Access Compliance Report

Public Rights-of-Way

Intersection ID: 47993	Main Street: HITCHCOCK_LN	Cross Street: MCCULLOUGH_DR	Location: SE
ADA ID: 4D5455B52EE4	Ramp Type: BlendTrans2	Initial Pass/Fail: Pass	Overall Compliance: No
		Severity Score: 2.75

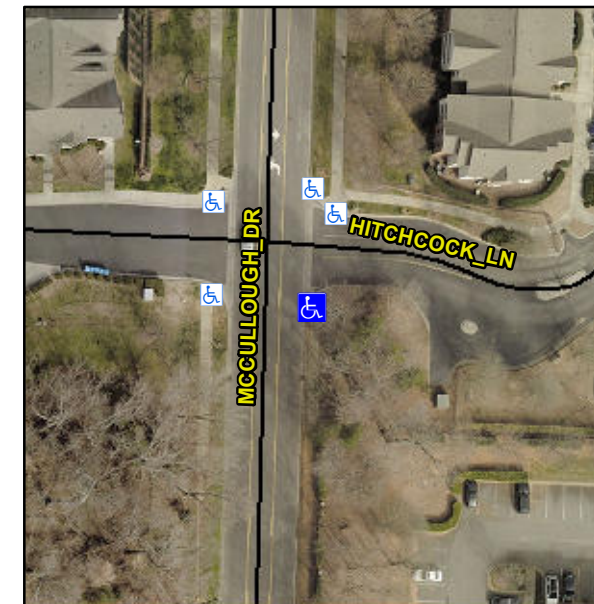
R304.5.3, R305.1.4, R305.2

Compliance	Description	Data	Compliance	Description	Data
N/A	Ramp Length (in)	64.0	Yes	BlendTrans Slope (%)	4.9
Yes	Ramp Width (in)	64.0	No	BlendTrans XSlope (%)	4.8
N/A	Flare Type LT	Sloped	N/A	Flare Type RT	Sloped
N/A	Flare Slope LT (%)	15.3	N/A	Flare Slope RT (%)	3.5
N/A	Flare Traversable LT?	No	N/A	Flare Traversable RT?	No
N/A	Landing Length (in)	N/A	Yes	DWS Provided?	Yes
N/A	Landing Width (in)	N/A	Yes	DWS Contrast?	Yes
N/A	Landing Slope (%)	N/A	Yes	DWS Length (in)	24.0
N/A	Landing X Slope (%)	N/A	No	DWS Full Width?	No
N/A	Landing Curb? (Y/N)	No	No	DWS Offset (in)	2.5
N/A	Shared Landing?	No			
Yes	Gutter Ponding?	No	Yes	Gutter Slope (%)	0.2
Yes	Gutter Lip Ht (in)	0.0	No	Gutter X Slope (%)	4.0
N/A	Painted X Walk1?	No	N/A	Painted X Walk2?	No
	X Walk 1 Direction	To N		X Walk 2 Direction	To W
	X Walk 1 Width (in)	N/A		X Walk 2 Width (in)	N/A
	X Walk 1 Slope (%)	2.5		X Walk 2 Slope (%)	2.9
	X Walk 1 X Slope (%)	11.1		X Walk 2 X Slope (%)	2.0

Remove & Replace Curb Ramp With Two New Directional Ramps or Equivalent. Remove & Replace Gutter.
